# Access Compliance Report

## Public Rights-of-Way

### (Curb Ramps)

Intersection ID: 44706	Main Street: AUSTON_CROSSING_DR	Cross Street: REAMES_RD	Location: SE
ADA ID: E93669D250B5	Ramp Type: Para	Initial Pass/Fail: Fail	Overall Compliance: No
Severity Score: 22.5			
Codes/Mitigation Info/Possible Solution		Field Measurements/Component Compliance

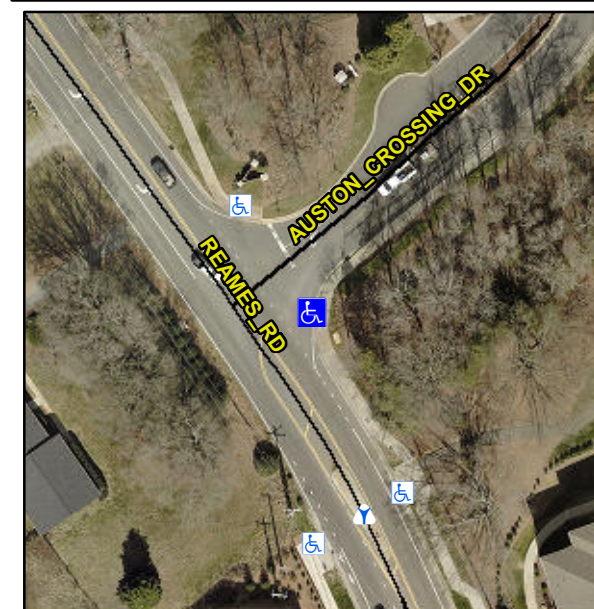
**RT RP < 5%**

**R304.5.1, R304.3.2, R304.5.3**

Compliance	Description	Data	Compliance	Description	Data
N/A	Ramp Length LT (in)	60.5	N/A	Ramp Length RT (in)	56.5
Yes	Ramp Width LT (in)	48.0	No	Ramp Width RT (in)	47.5
No	Ramp Slope LT (%)	8.9	Yes	Ramp Slope RT (%)	3.8
No	Ramp XSlope LT (%)	2.2	Yes	Ramp XSlope RT (%)	1.0
N/A	Landing Length (in)	N/A	N/A	DWS Provided?	N/A
N/A	Landing Width (in)	N/A	N/A	DWS Contrast?	N/A
N/A	Landing Slope (%)	N/A	N/A	DWS Length (in)	N/A
N/A	Landing X Slope (%)	N/A	N/A	DWS Full Width?	N/A
N/A	Landing Curb? (Y/N)	N/A	N/A	DWS Offset (in)	N/A
N/A	Shared Landing?	N/A			
N/A	Gutter Ponding?	N/A	N/A	Gutter Slope (%)	N/A
N/A	Gutter Lip Ht (in)	N/A	N/A	Gutter X Slope (%)	N/A
N/A	Painted X Walk1?	No	N/A	Painted X Walk2?	N/A
	X Walk 1 Direction	To N		X Walk 2 Direction	N/A
N/A	X Walk 1 Width (in)	N/A	N/A	X Walk 2 Width (in)	N/A
	X Walk 1 Slope (%)	2.5		X Walk 2 Slope (%)	N/A
	X Walk 1 X Slope (%)	1.3		X Walk 2 X Slope (%)	N/A
N/A	Ramp inside XWalk1?	N/A	N/A	Ramp inside XWalk2?	N/A

**Remove & Replace Entire Ramp.**
